NEW LIBRARY
LEARNING
RESOURCE
CENTER BUILDING

**LANDSCAPE SITE
LAYOUT PLAN**

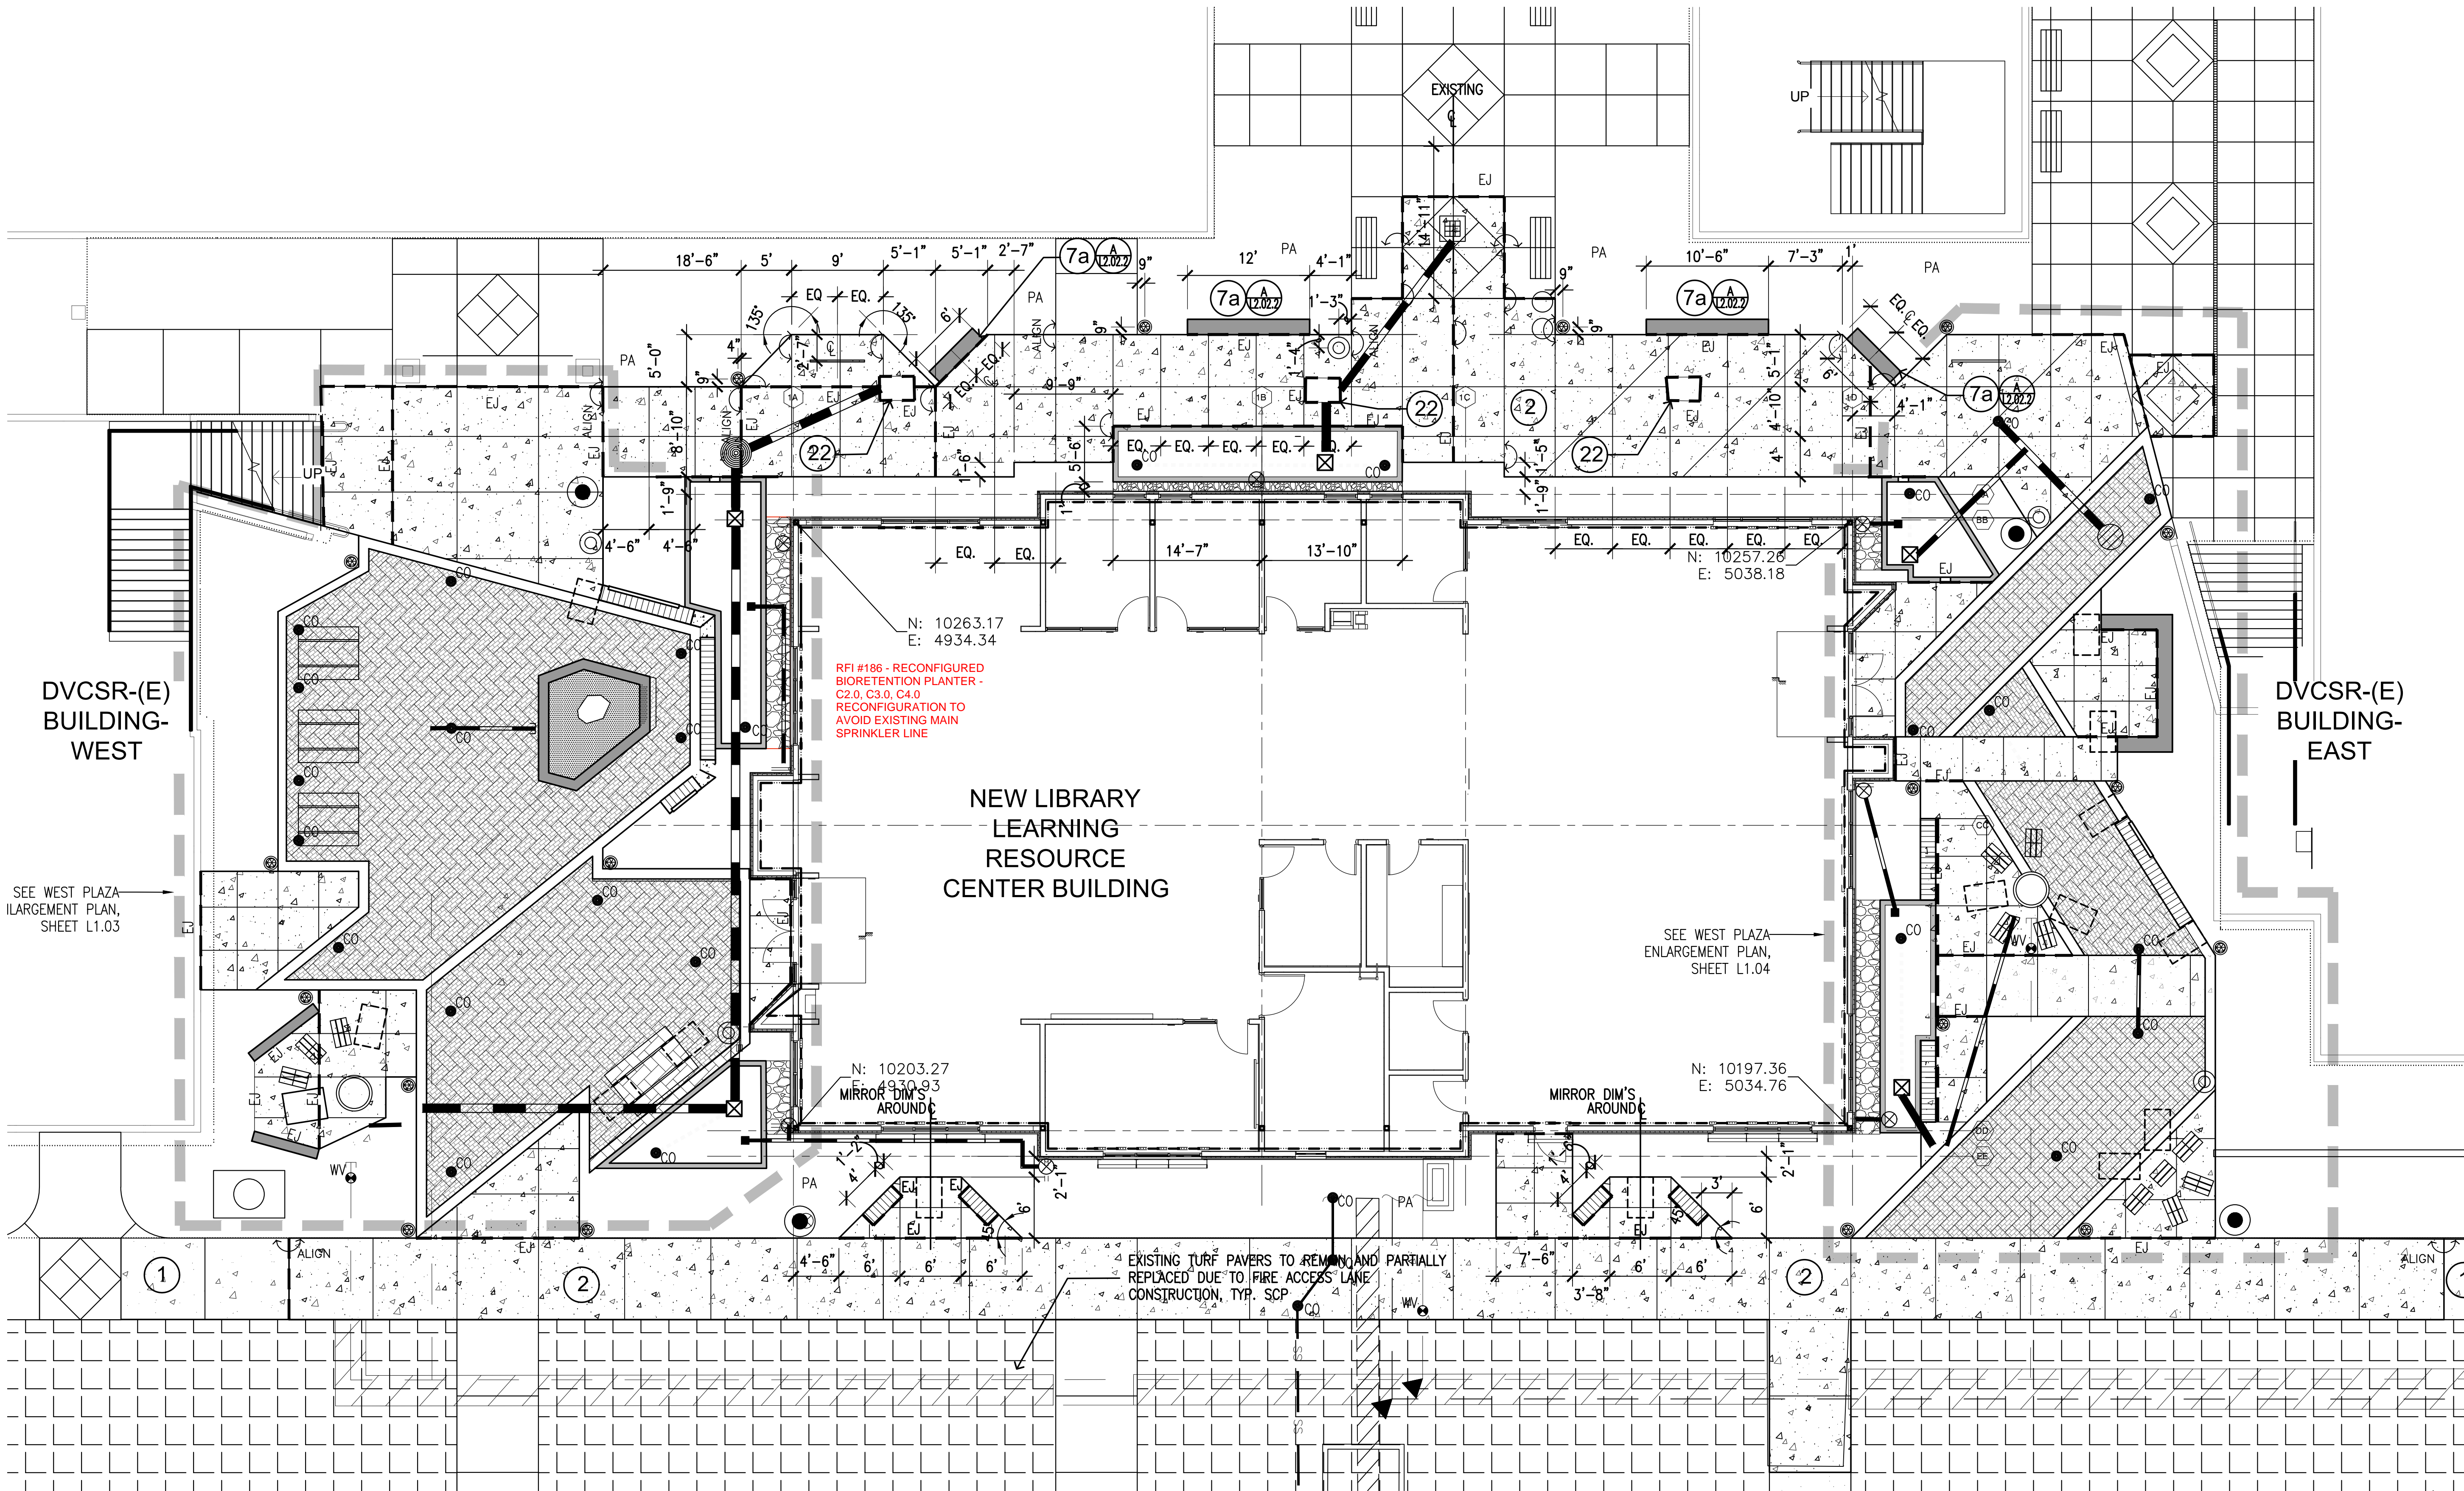
RFI #242 - SOD LAYDOWN AREA REPAIR - 90/10 TALL FESCUE

RFI #246 - TIMELOCKS FOR (3) FOUNTAINS. USE SINGLE TIMELOCK FOR 3 FOUNTAIN PUMPS. CIRCUIT THE 2 SMALLER PUMPS (PAF-405V) TO LLRC-59 WITH 20A GFCI CIRCUIT BREAKERS AS SHOWN ON E4.01.2. PROVIDE ADDITIONAL CIRCUIT FOR LARGE FOUNTAIN PUMP (PAF-755V). LLRC-57, 20A GFCI CIRCUIT BREAKER.

A0.01.0

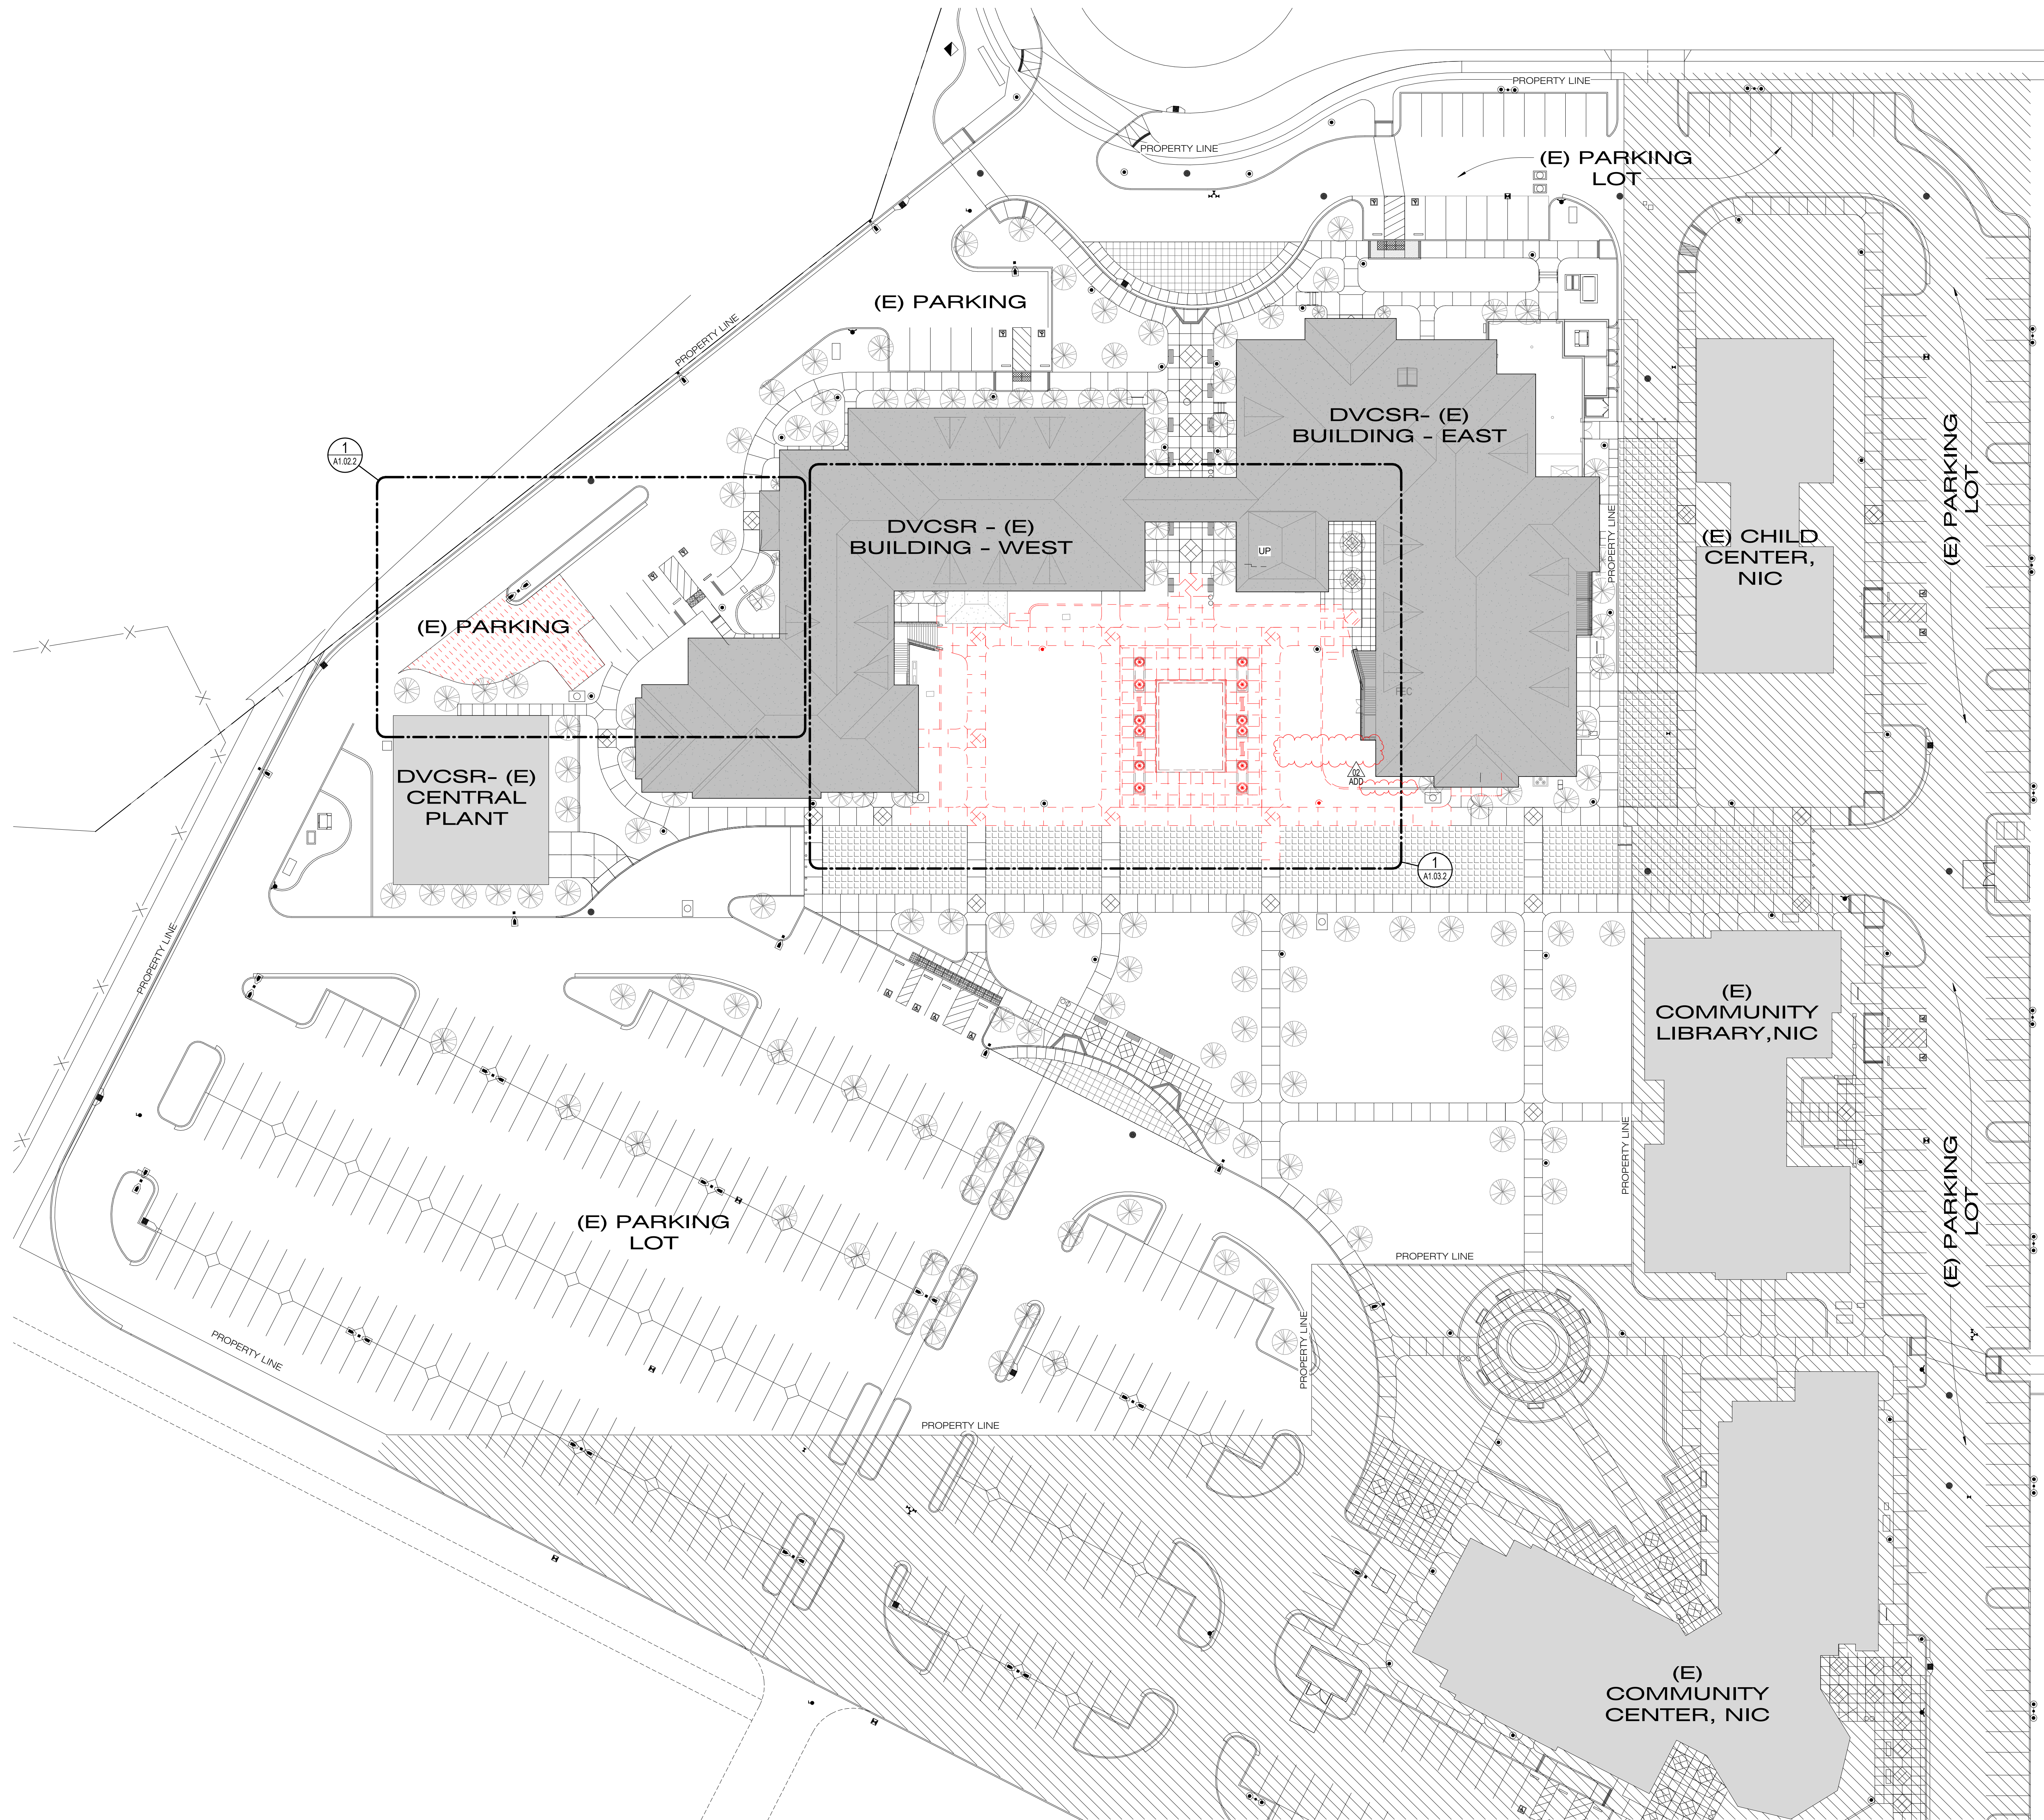
RFI #6 - IN THE FIRE LANES THERE IS EXISTING TURF BLOCK GRASS PAVE 2'. PER GENERAL NOTE 6 ON C2.0, THE CONTRACTOR RESPONSIBLE FOR REPLACEMENT OF ALL TURF BLOCK THAT ARE REMOVED FOR NEW IMPROVEMENTS. ALSO PER NOTE 5 CONTRACTOR TO RESTORE FEATURES WHICH ARE DAMAGED TO PREVIOUS CONDITION.

A2.30C.2

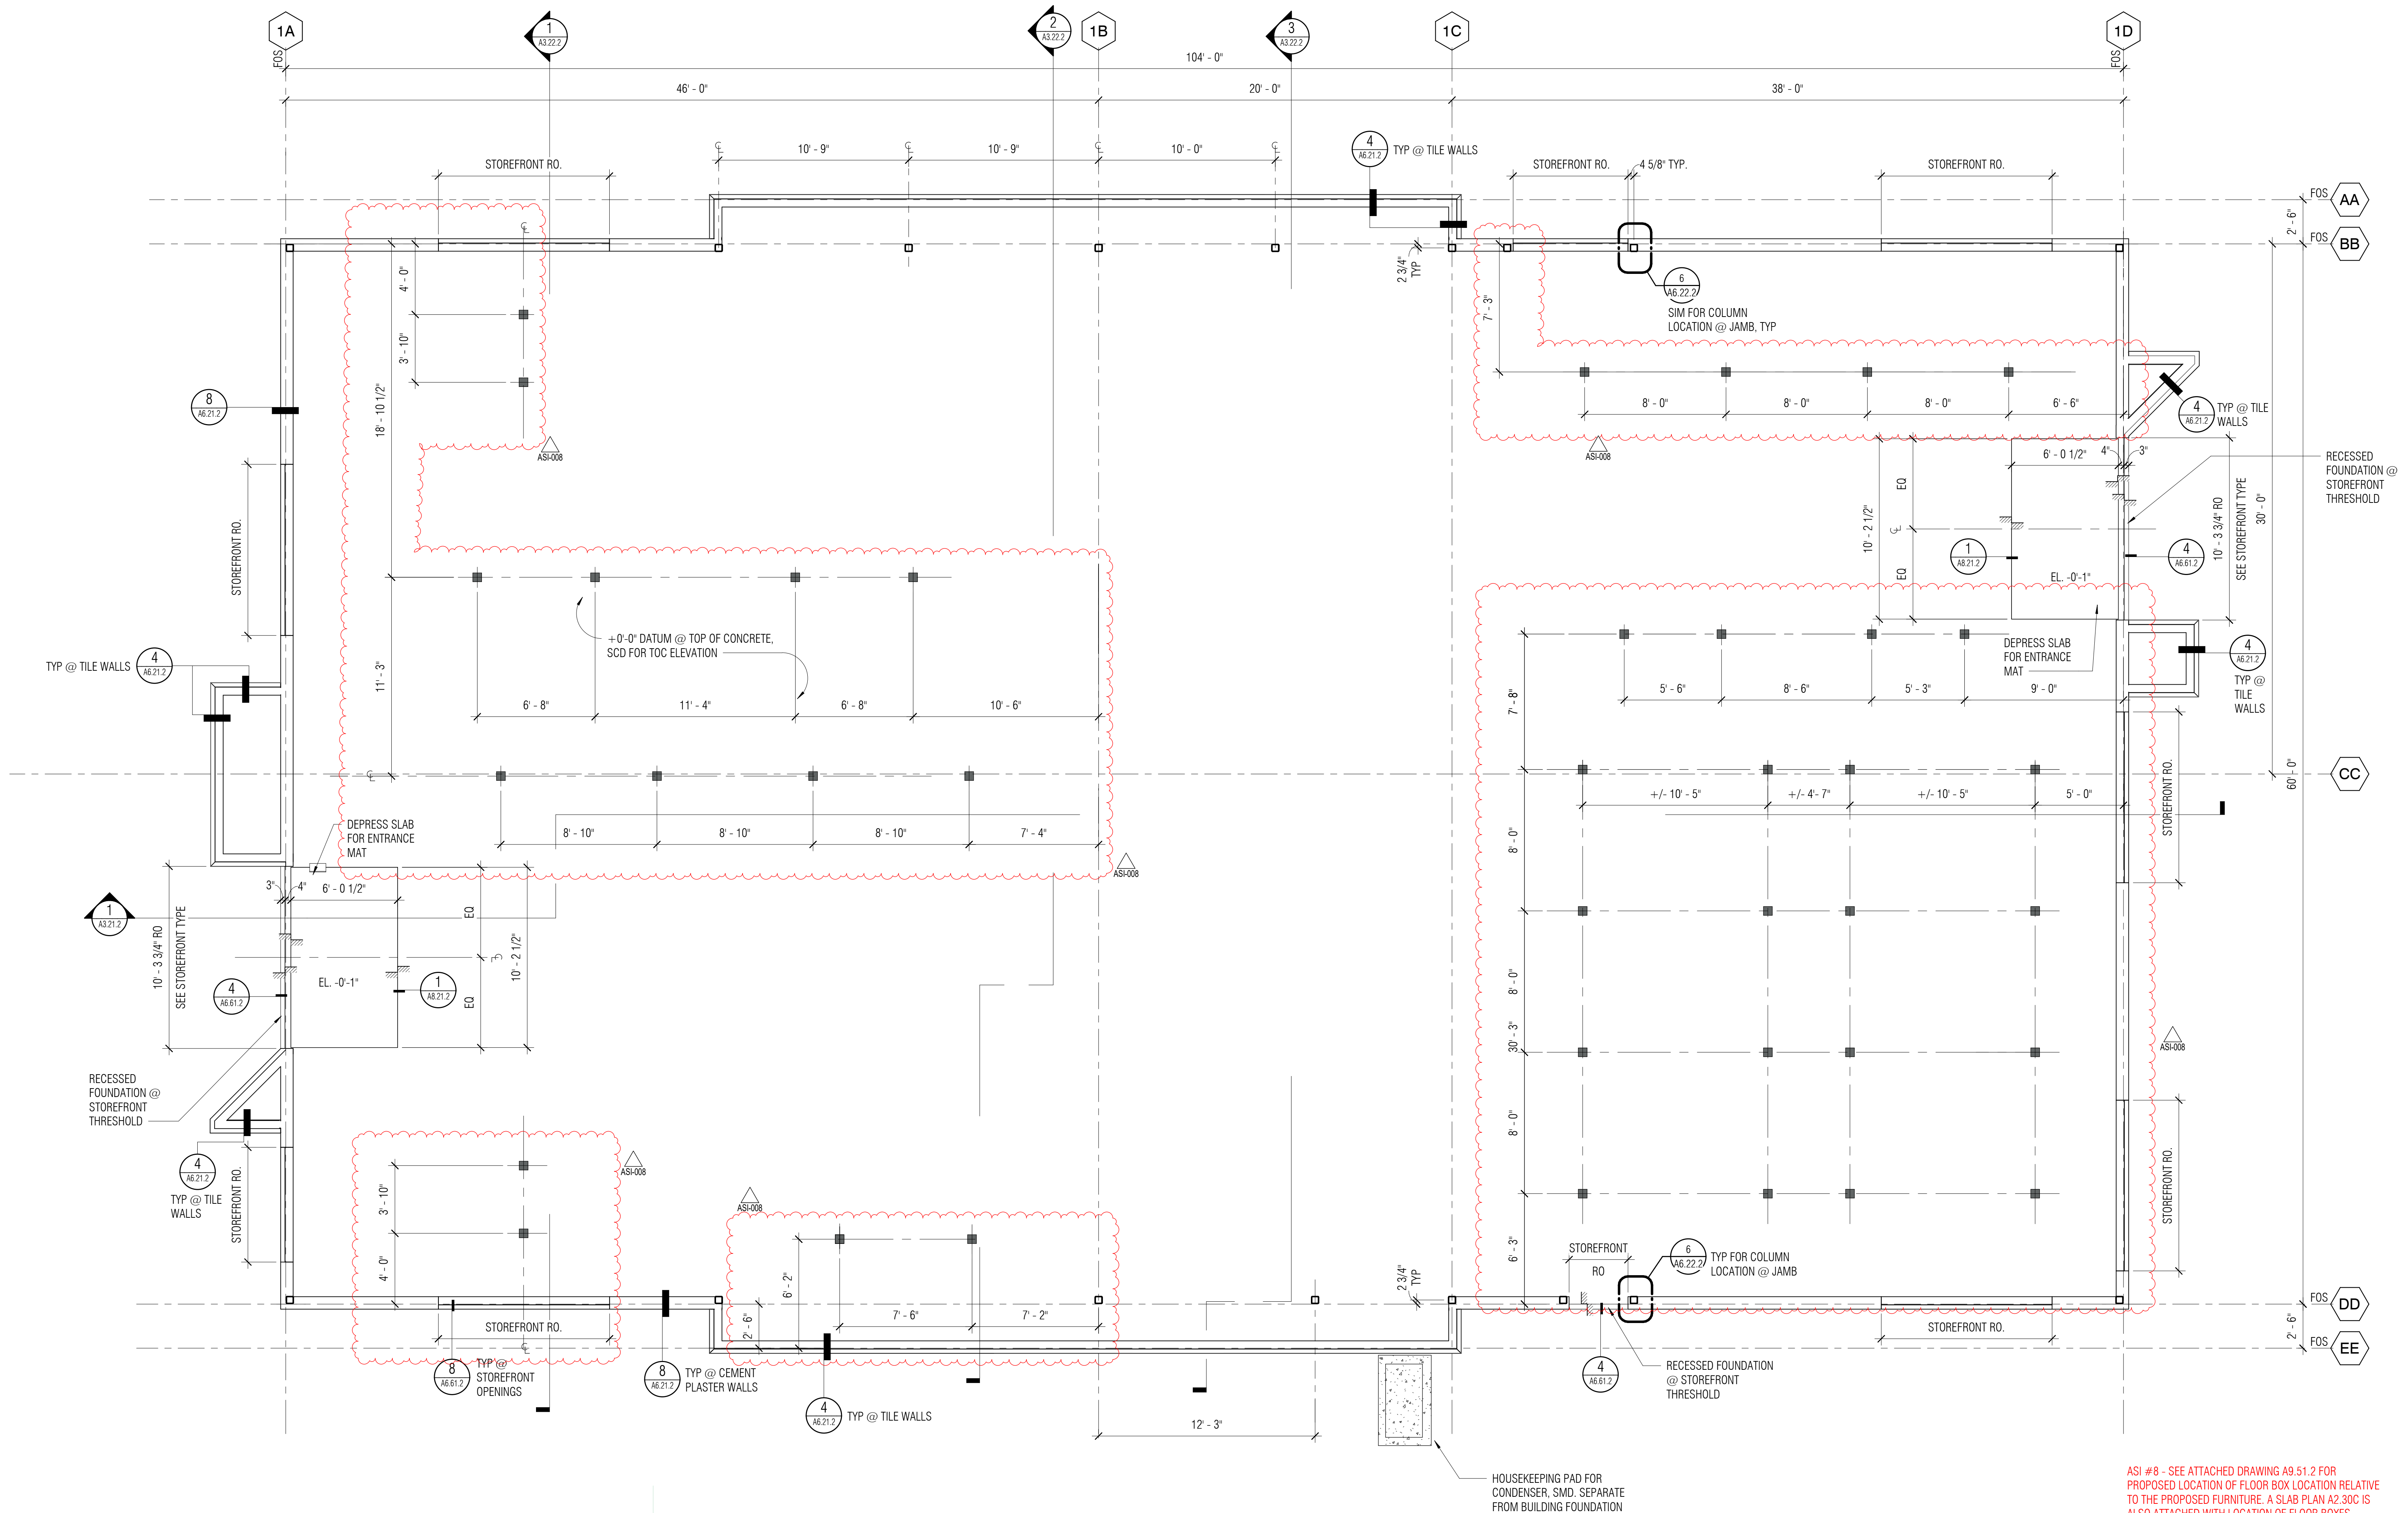
ASI #8 - SEE ATTACHED DRAWING A9.51.2 FOR PROPOSED LOCATION OF FLOOR BOX LOCATION RELATIVE TO THE PROPOSED FURNITURE. A SLAB PLAN A2.30C IS ALSO ATTACHED WITH LOCATION OF FLOOR BOXES.
